SERVICE BULLETIN

M-1408E

September 16, 2015

2014-2015 TOURING SADDLEBAG MOUNT - SAFETY RECALL 0166

Figure 1. Saddlebag Stud Receptacles (shown inverted from installed position)

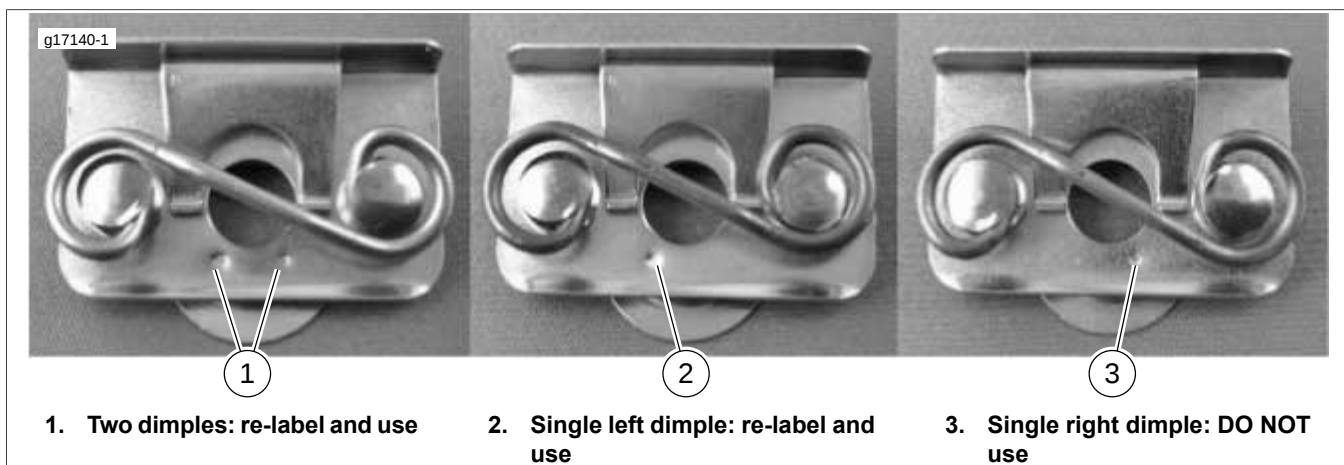
1. Inspect all dealer inventory of kit 91500084.
 - a. If package has a date code of 07/14/15 or earlier, parts are good. Add an "A" after the part number.
 - b. See Figure 1. Inspect all later date code inventory of kit 91500084 as shown in Figure 1.
 - c. Add an "A" to all kits that pass inspection.
2. For kits that fail inspection, see 91500084 KIT RETURN PROCESS.

Some kits have stud receptacles with a green paint mark. All kits (Part No. 91500084A) are approved for use, including those containing receptacles with a green paint mark.

Figure 2. Saddlebag Stud Receptacles

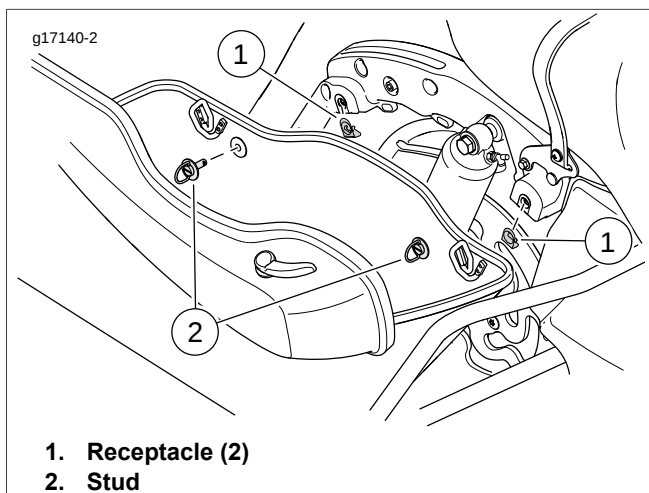
1. Verify that the motorcycle is involved in this recall.
2. See Figure 2. Remove saddlebags.
3. Remove receptacles (1).
 - a. Insert a small screwdriver between receptacle clip and edge of saddlebag support.
 - b. Pry receptacle from saddlebag support.
4. Install **new** receptacles supplied in kit.
5. Install saddlebags using original studs (2) and washers.
6. Confirm that stud has been rotated a **full 90 degrees** to ensure complete engagement.
7. When returning the motorcycle, remind the owner of the importance reading and following the saddlebag installation instructions provided in the owner's manual.
